SERVICE BULLETIN

TITLE: Improve joint strength under the driver side window

PRODUCT: G5 School vehicles, 2008-2009, 158"/159" Wheelbase

Reference : recall 10-039-JSU

Figure 2

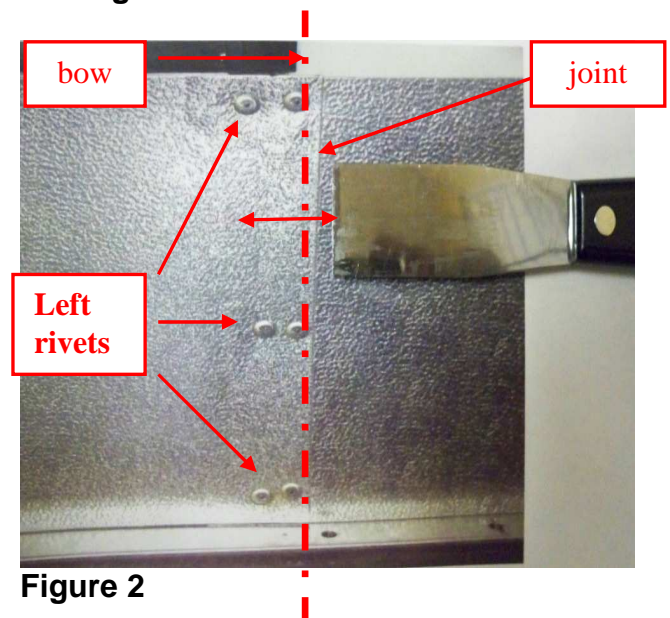
2- Locate the joint and check to see if adhesive was applied between the panels using a small spatula (Figure 2)

The aluminium panel joint affected by this recall is located on the left side (driver side) under the first window.

Easily identifiable by six (6) rivets;
 (3) Rivets located in the bow.
 (3) Additional rivets join both panels together. (Figure 2).

If the spatula can be inserted beyond the left rivets, there is no adhesive. Follow the steps below to correct the situation.

Figure 3

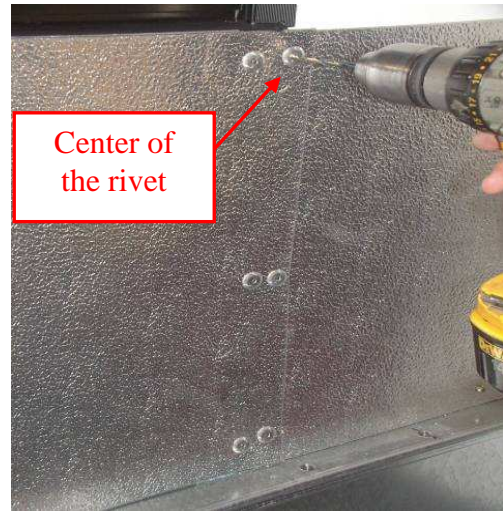
Using a drill and drill bit 13/64", place the bit in the center of the rivet and drill it to remove its head (Figure 3). The six (6) rivets must be removed (Figure 4).

It is recommended to stop drilling as soon as the head of the rivet is removed on your drill. Do not drill more than 1/2" (Figure 4)

Figure 7

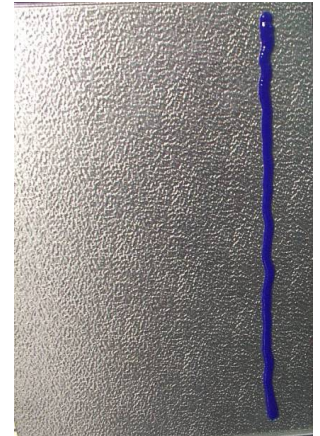
5- Apply an adhesive strip of at least ¼" (Figure 7).

Apply the strip vertically between the rivet holes to ensure that the adhesive does not overflow (Figures 6 & 7).

Figure 8

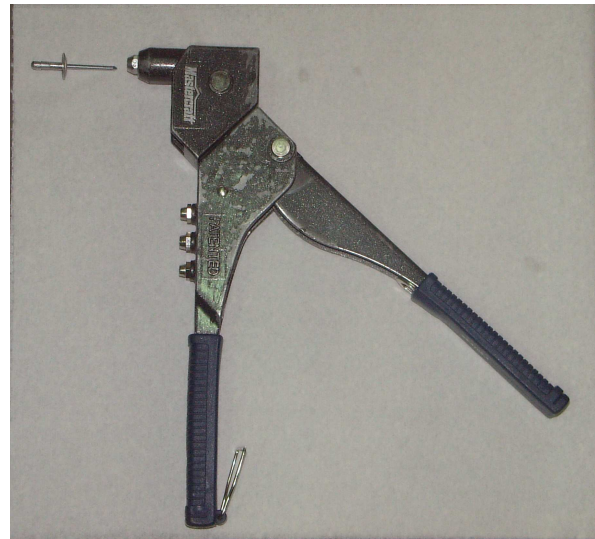
6- Install six (6) aluminum rivets with a hand riveter (Figure 8).

Figure 9

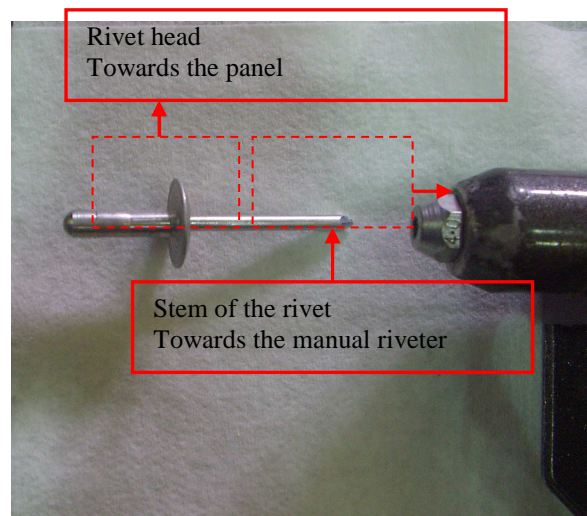
Method to insert the rivets in the manual riveter (Figure 9).
